EZ-ALIGN SERVICE BULLETIN SERVICEABILITY

Trailer Air Suspensions

EZ-Align Identification - Old Style vs. New Style

January 21, 2002

FIGURE 1A:
OLD STYLE FRAME BRACKET ALIGNMENT COLLAR

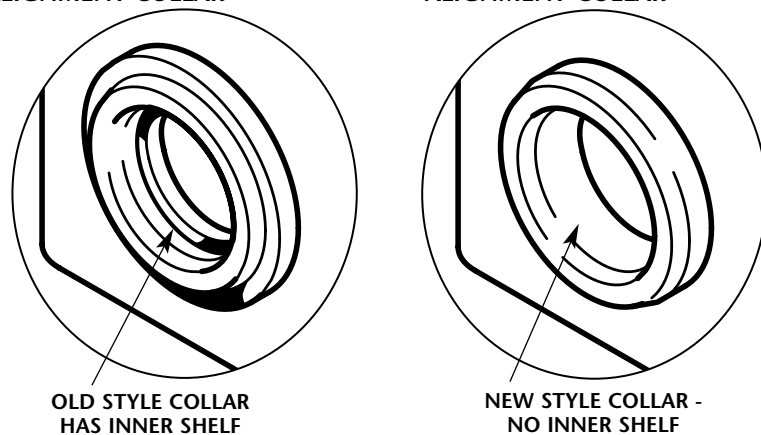
The old style frame bracket collar can be identified by an inner shelf inside the collar. This inner shelf will not allow the new style alignment blocks or alignment block/hex bolt assembly to mate properly (FIG. 1A & 4). The old style alignment block and alignment block/hex bolt assembly are shown in Figure 2, page 2.

FIGURE 1B:
NEW STYLE FRAME BRACKET ALIGNMENT COLLAR

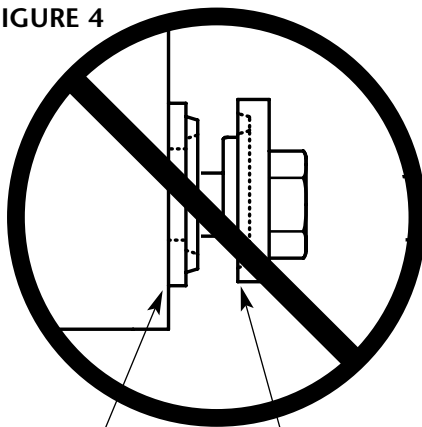
The new style frame bracket alignment collars do not have an inner shelf (FIG. 1B). The new style alignment block and alignment block/hex bolt assembly are shown in Figure 3, page 2. New style can be identified by a protrusion nose on the inside surface (FIG. 3) the old style alignment blocks **DO NOT** have this nose (FIG.2).

FIGURE 3: NEW STYLE EZ-ALIGN

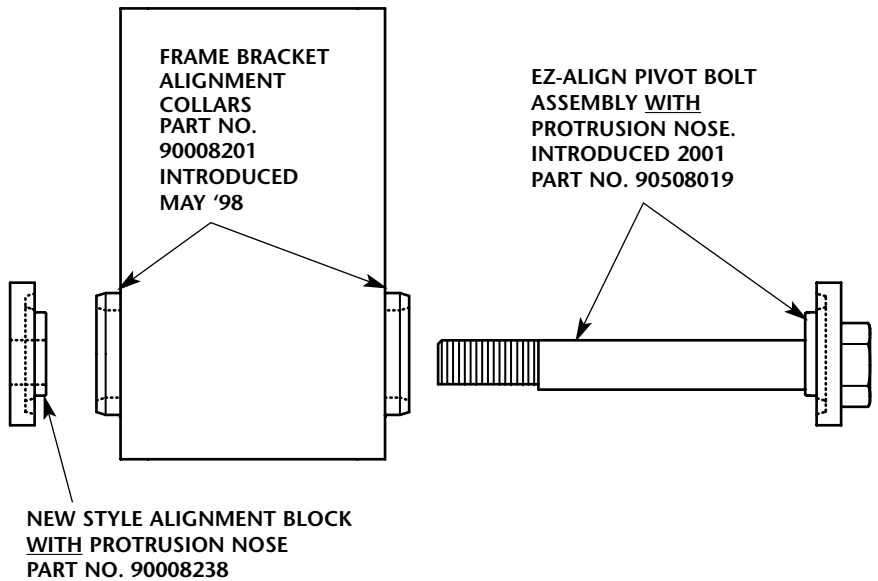
The EZ-Align frame bracket collar design was simplified in May 1998 as a manufacturing improvement. The EZ-Align alignment block that is welded to the pivot bolt head and the mating alignment block with the D-shaped hole was reengineered in late 2001 to improve OEM assembly time and alignment. The new improved alignment block design has a protrusion that allows for easier assembly and alignment. The new components are currently being released into all NS, RL and RLU series air-ride suspensions as a running change.

IMPORTANT: When servicing the EZ-Align pivot connection of a Holland Neway trailer suspension, it is critical that the new EZ-Align pivot bolts and alignment blocks are not assembled to frame brackets with the old style (pre May 1998) alignment collars. The following instructions will assist in identifying old vs. new style components. To assure part compatibility, Service Repair Kits (SRKs) will only be sold with the old style components that can be used with either frame bracket configuration.
